SAFETY RECALL BULLETIN

Subject: **Safety Recall 09C4**
EPA07 DD15 Grid Heater

Figure 2 – Negative (Ground) Cable Connection At Grid Heater

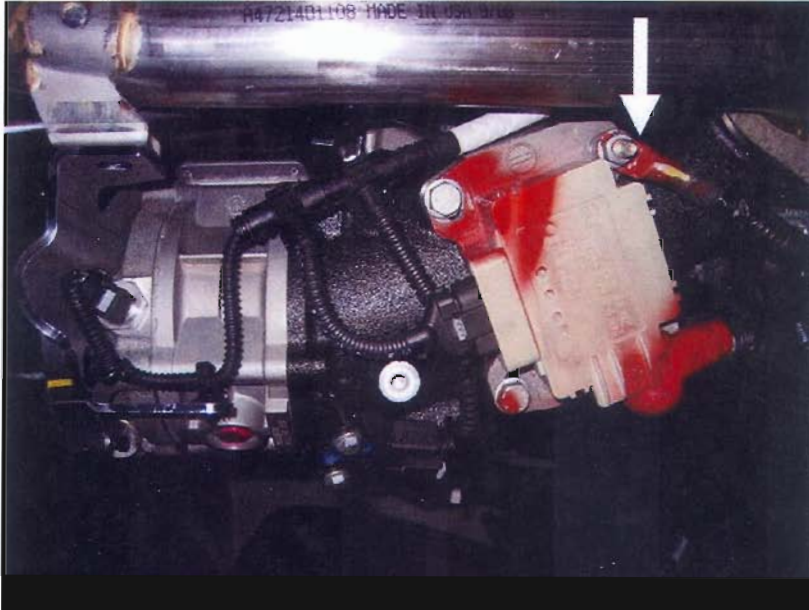
7. Turn the vehicle ignition OFF and disconnect the batteries.
8. Disconnect the negative (ground) cable from the grid heater and the vehicle frame and completely remove the cable from the vehicle. See Figure 2.

Figure 3 – Positive Cable Connection At Grid Heater

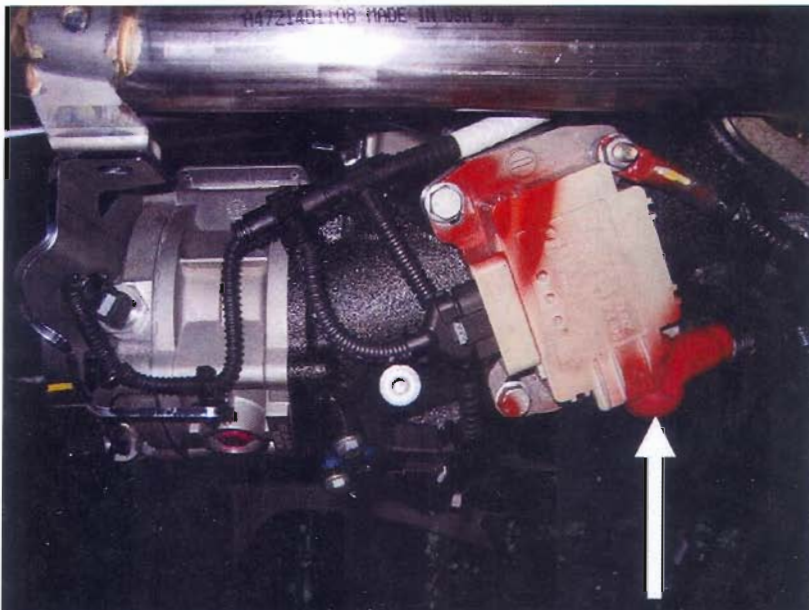
9. Disconnect the positive cable from the grid heater. See Figure 3.
